## Whitehouse Planning Commission Meeting Notice

**WHITEHOUSE PLANNING COMMISSION  
PETITION FOR A ZONING MAP AMENDMENT  
STAFF REPORT #02-2019  
May 6, 2019**

**STAFF REPORT  
PLANNING COMMISSION  
PRELIMINARY PLAT APPLICATION  
WHITEHOUSE MEADOWS – STAFF REPORT #03-2019  
May 6, 2019**

**STAFF REPORT  
PLANNING COMMISSION  
Renewal of Preliminary Plats for Steeplechase Plats 6 & 7  
Staff Report #04-2019  
May 6, 2019**

#### TYPICAL MINIMUM LOT DIAGRAMS

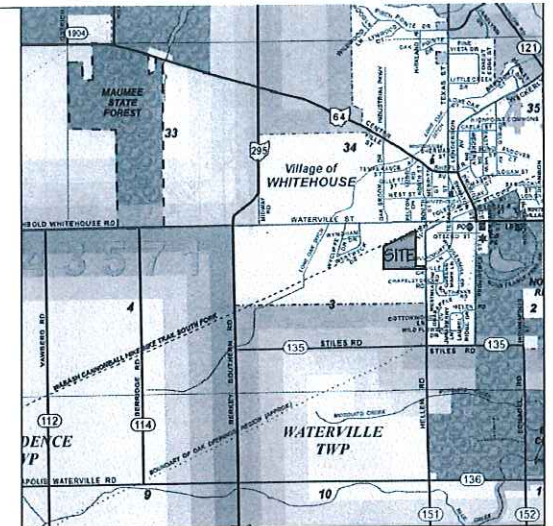
In the upper left hand corner of the Preliminary Drawing, the Typical Minimum Lot Diagram shows front and rear yard setbacks of 25 feet. This will need to be changed to show front setbacks of 30, with no rear yard requirement, unless the Planning Commission approves and recommends otherwise.

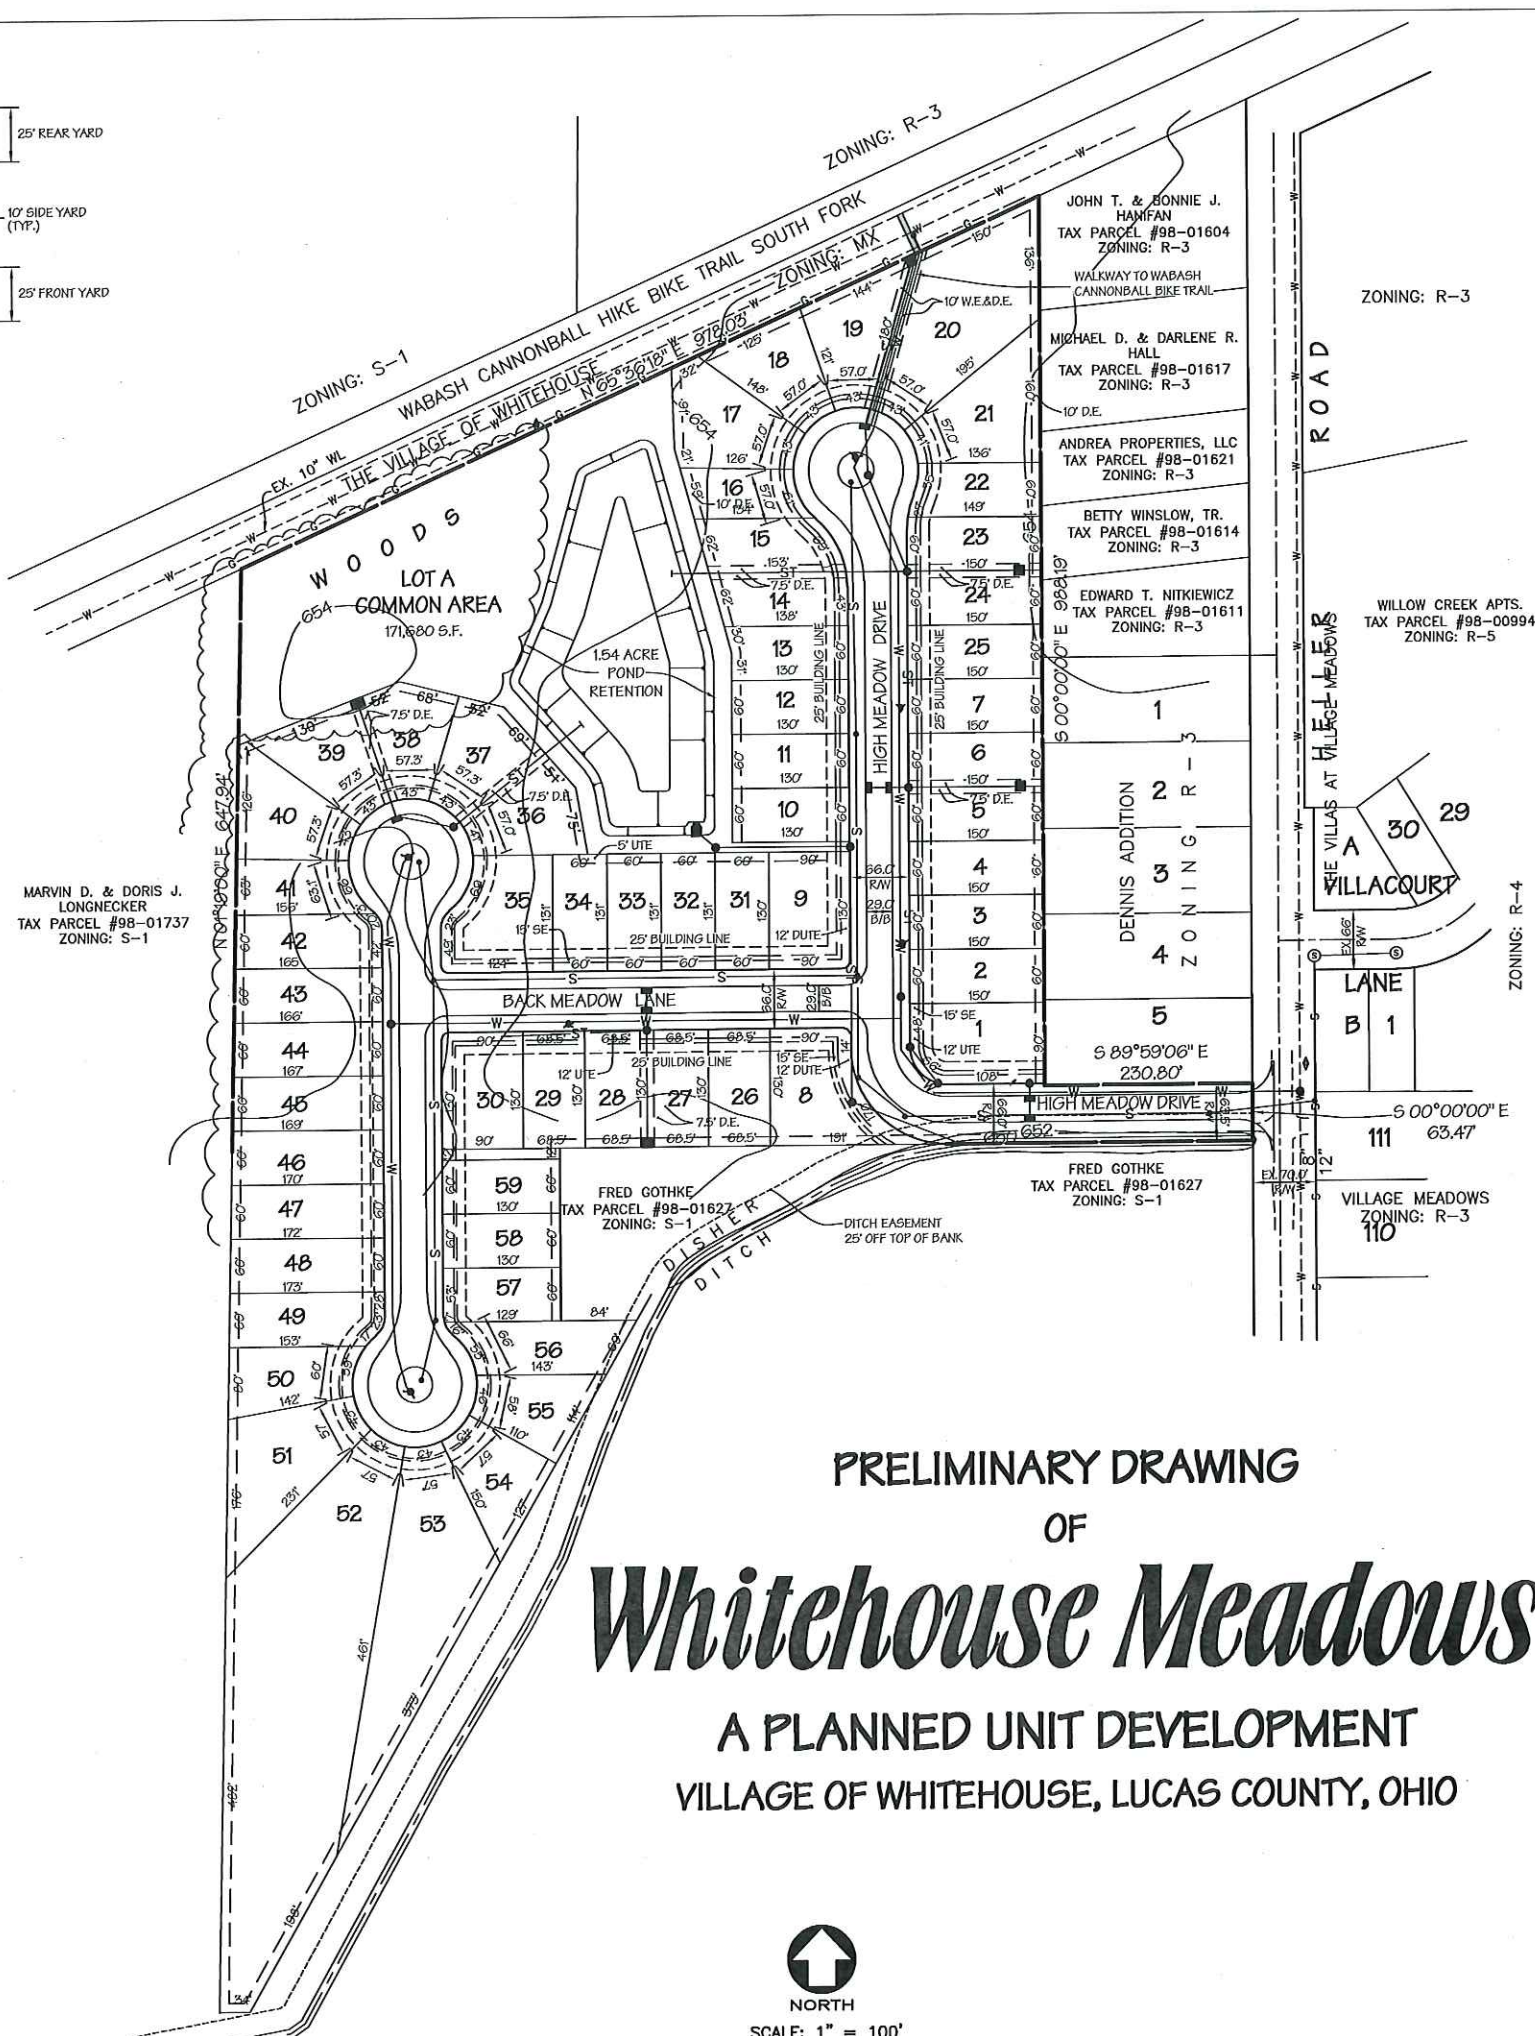
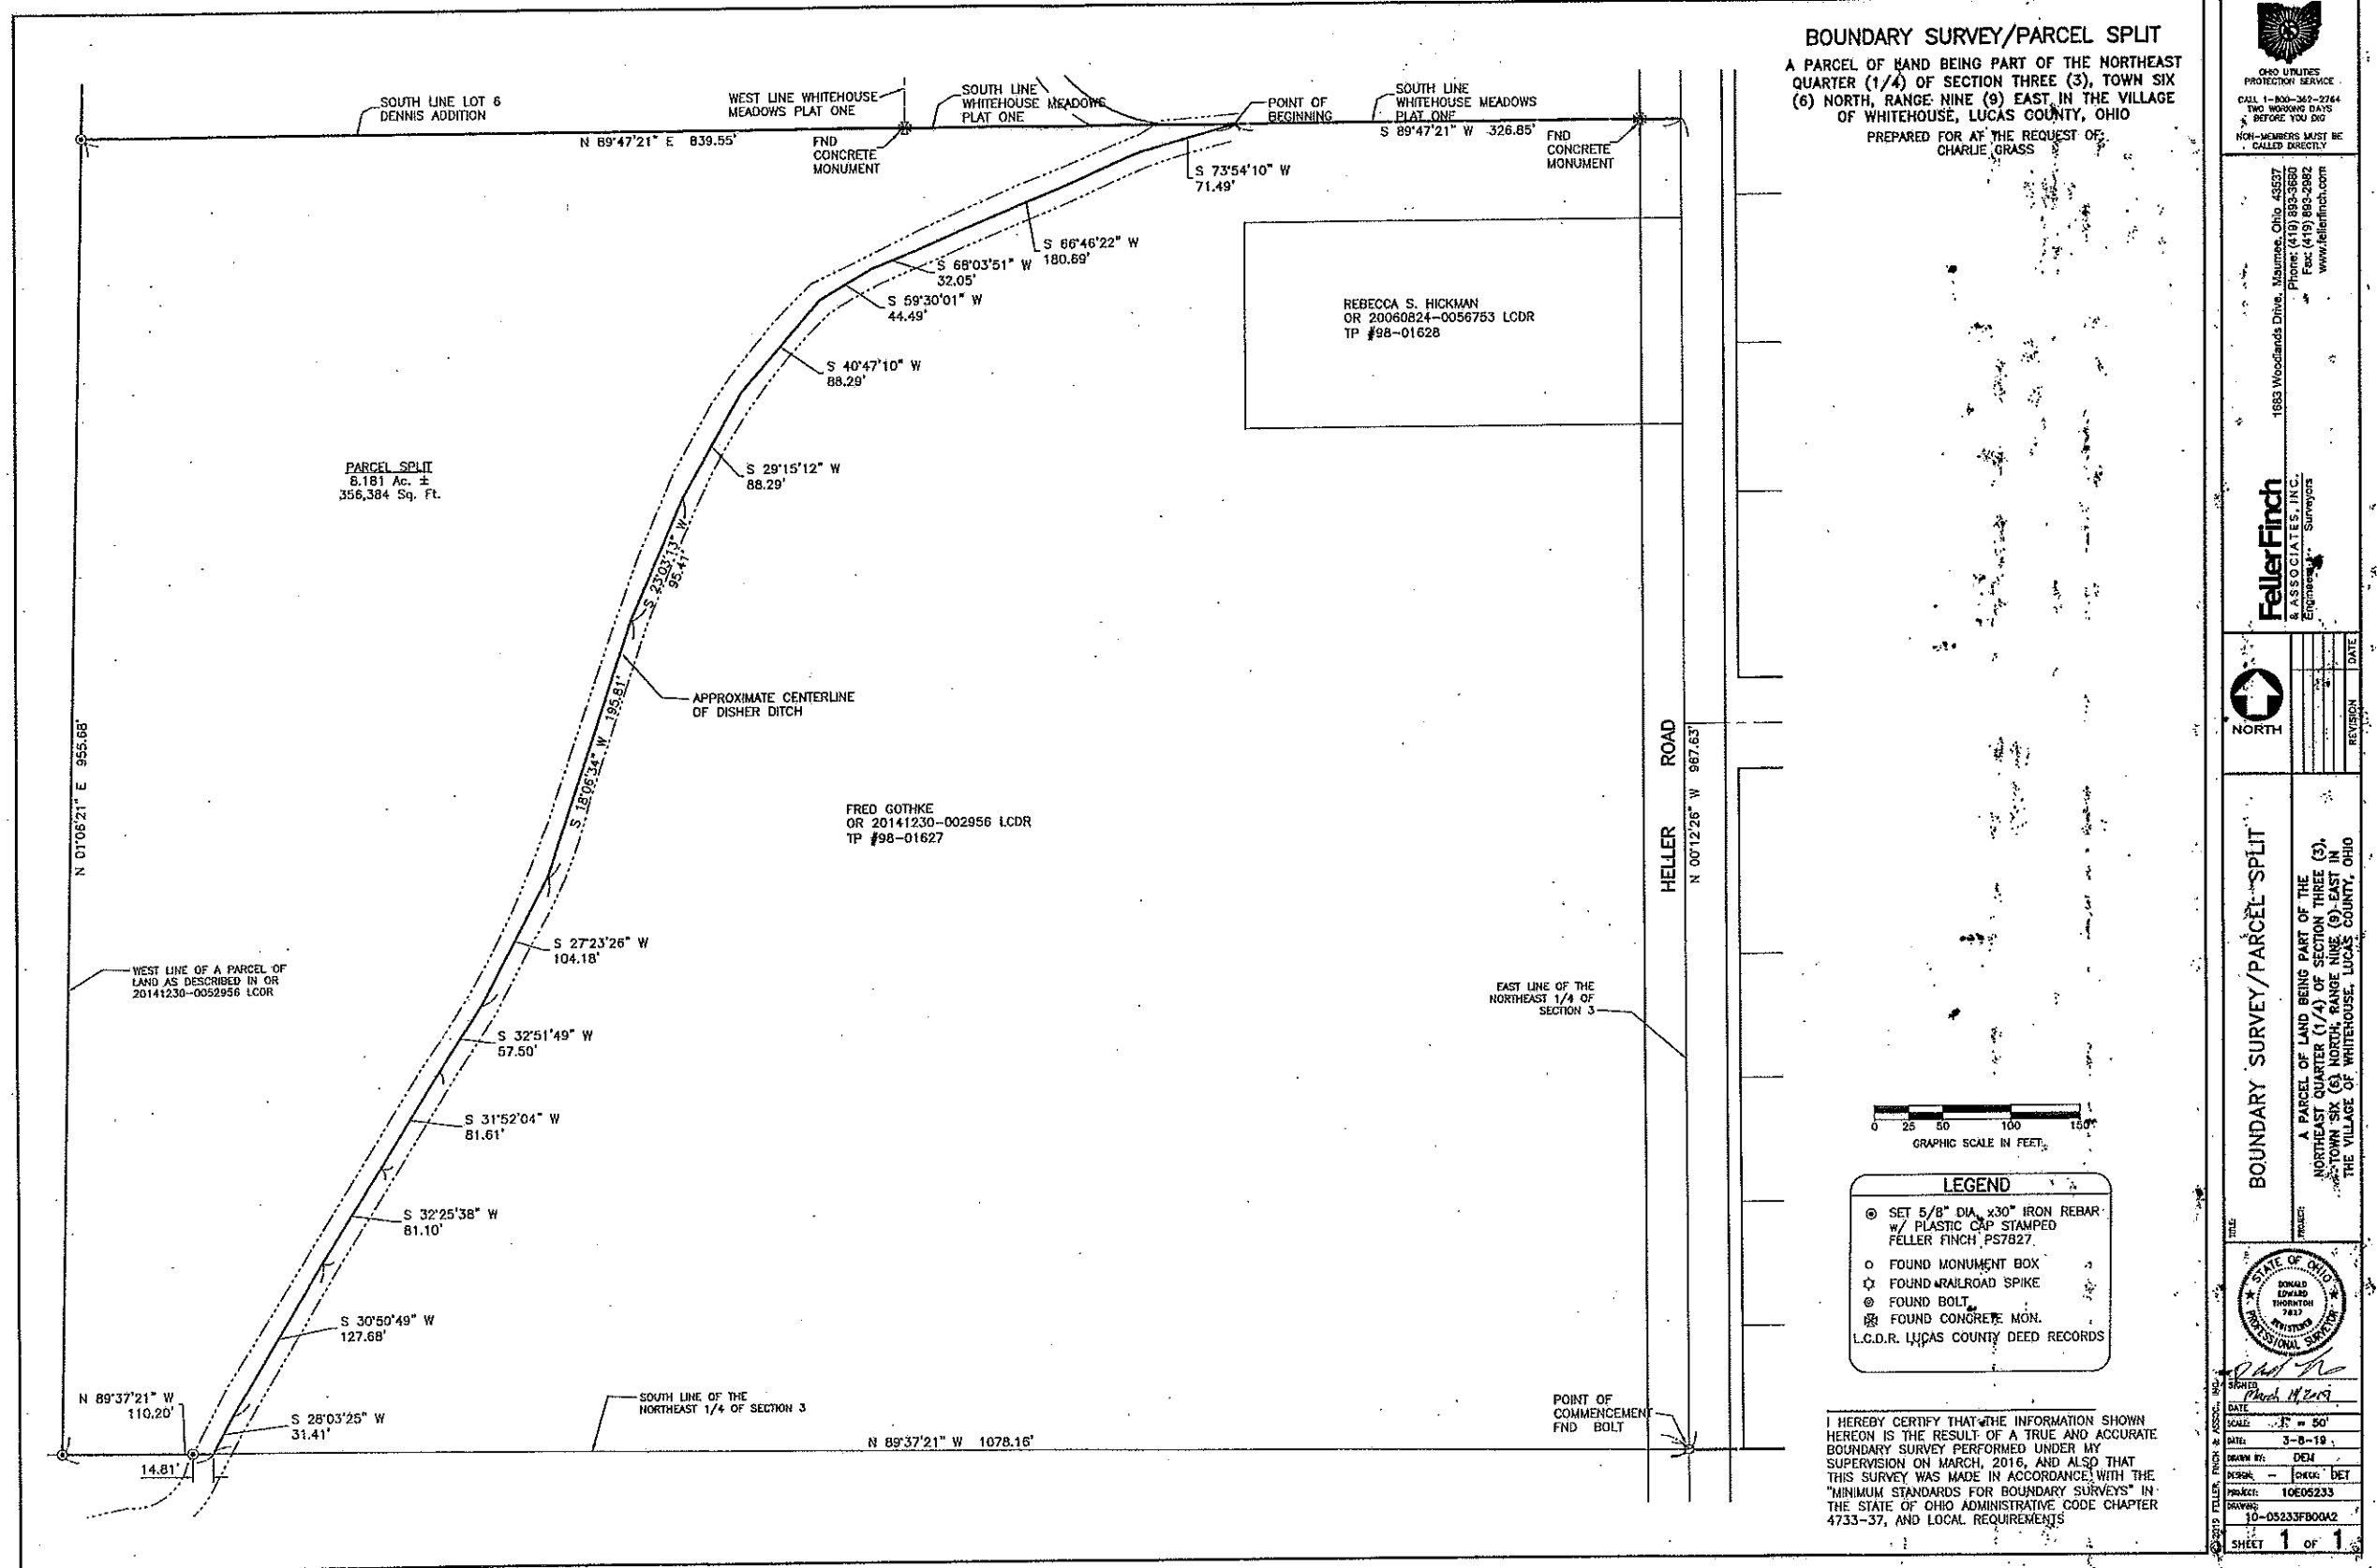
- 2. Chapter 1127.02 (C) of the Subdivision Regulations states *“All corner residential lots shall have extra width sufficient for maintenance of building lines on both streets. The minimum width shall be 100 feet.”* The Preliminary Drawing shows two corner lots (30 and 35). Lot 30 shows a width of 130 feet on Red Stag Court, however, it only has a width of 90’ on White Tail Lane. This is a deficiency of 10 feet per this Chapter of the Subdivision Regulations and a variance would be required if approval is granted.

- 3. 1127.03 (E) states *“Any water mains serving a cul-de-sac shall be looped.”* Mr. Grass has shown the water line coming in off of Heller Road on Big Buck Trail and looping at the end of White Tail Lane into the waterline running along the Wabash Cannonball Trail. However, he does not show a loop at the end of the Red Stag Court cul-de-sac. This line will also need to be looped.

- 4. 1127.05 (C) states *“In cases of green space reserved for exclusive use of residents of a project or for parkland created and maintained by a homeowners’ association, restrictions for use of the land shall be placed on the subdivision or plat drawing and on deeds for the land.”* Will the Lot A Common Area and 1.5 Acre Pond be used for the exclusive use of residents of this subdivision? Is this usable space?

EXHIBIT "B"

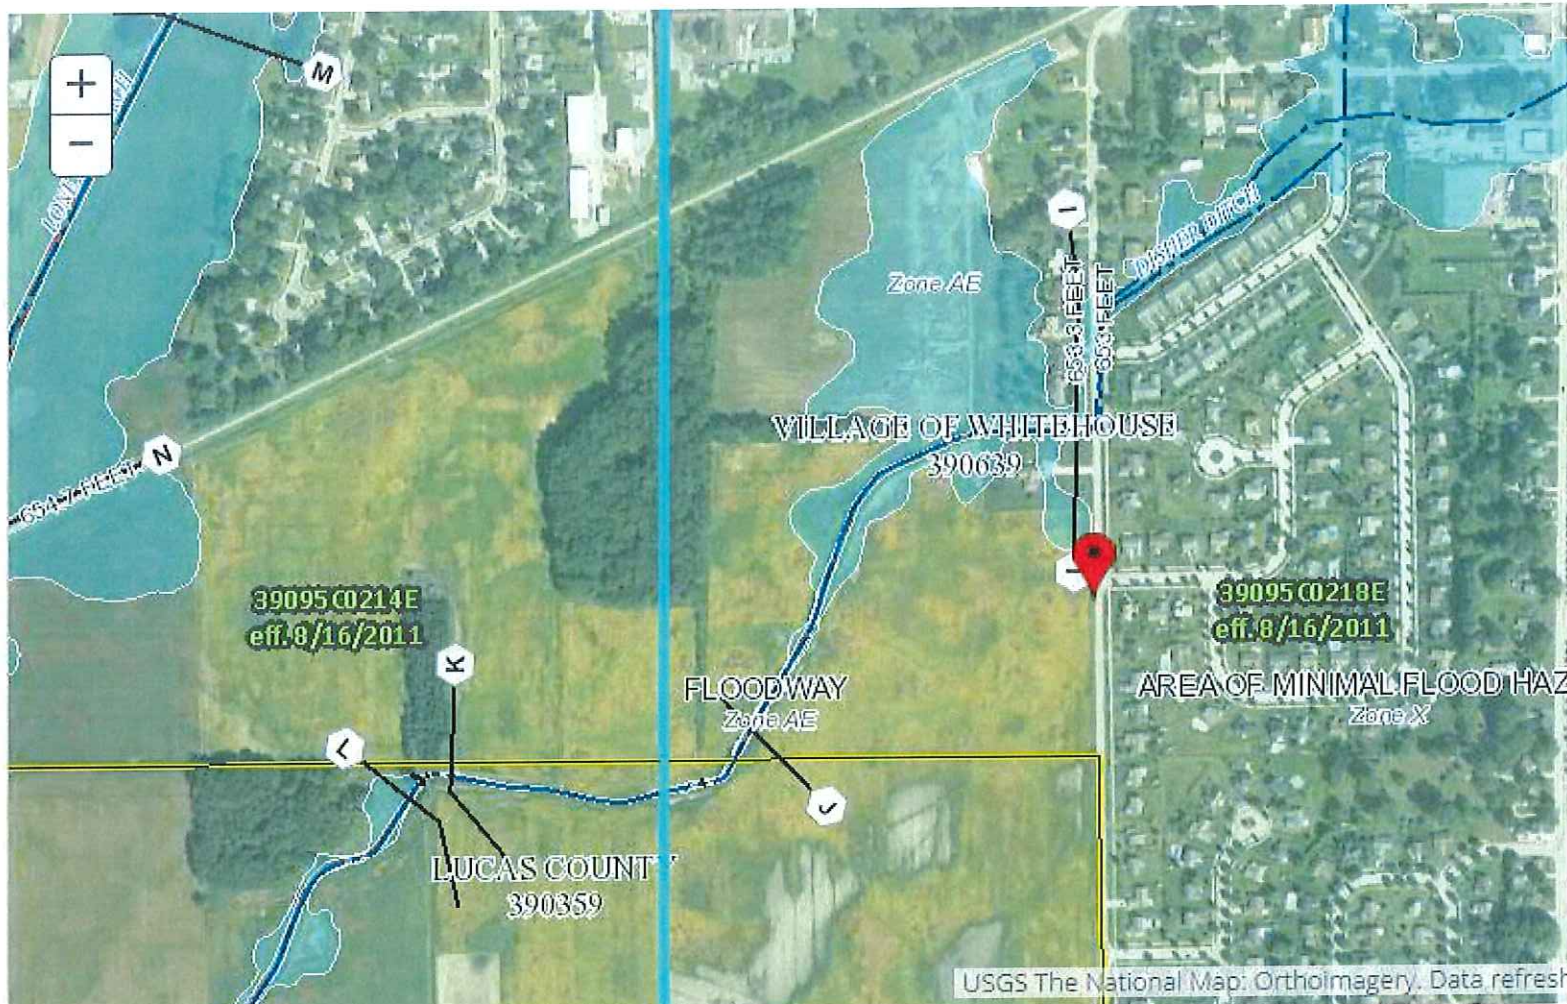
6. 1127.09 of the Subdivision Regulations states *“No plat will be approved when more than 10% of the lots planned thereon are in excess of one foot below the high water level at the building site.”*. A copy of the FEMA map for this parcel is attached (Exhibit B) and it appears that portions are in the flood plain.
